# **8XC152JX**

## **SPECIFICATION UPDATE**

Release Date: July, 1996

Order Number: 272882-001

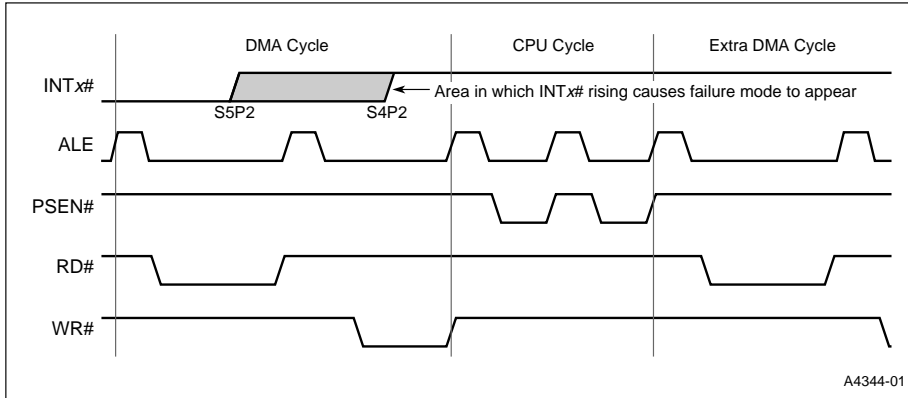
**PROBLEM:** In Global Serial Channel on the 8XC152, RFIFO pointers are not reset when GREN is set. Since the pointers are not reset, RFNE will not be cleared (the error bits will still be reset).

**IMPLICATION:** Error bits remain reset when GREN is set.

**WORKAROUND:** The fact that the RFIFO pointers are not reset can be worked around by checking RFNE every time GREN is set. If RFNE = 1, the data must be emptied out under program control as shown in the example below. The emptying of RFIFO must be completed before 24 (40) bit times have elapsed when using the 16 (32) bit CRC. One method of doing this is to move the data into the accumulator. All discussions talking about the users manual also applies to the hardware description found in the ECO handbook. An example of the software that would be executed is:

**External to External Transfer (1 Transfer Shown)**

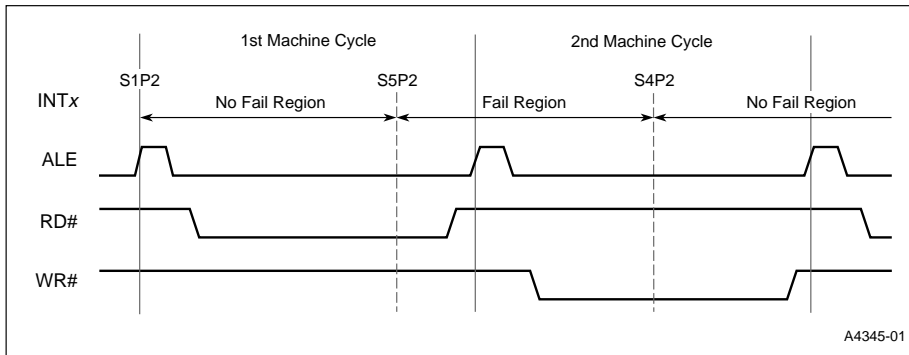
**PROBLEM:** On the 8XC152JA/JB/JC/JD, a failure mode occurs by using either DMA channel in level-sensitive, external demand mode. If, after a transfer begins, the INTx pin goes high between S5P2 and S4P2 of a DMA cycle, an extra DMA transfer will take place.

**IMPLICATION:** The condition above applies to all single-machine-cycle transfers. All DMA transfers take one machine cycle except the external-external transfer which takes two. For this mode, the bug appears only if INTx goes high between S5P2 of the first machine cycle, and S4P2 of the second.

The diagrams below illustrate the areas of a DMA transfer during which the rising edge of the INTx pin will and will not cause the bug to appear. Each of the four transfer modes are shown.

**WORKAROUND:** At this point there are no known software or hardware workarounds. The following diagram gives a graphical description of the anomaly.
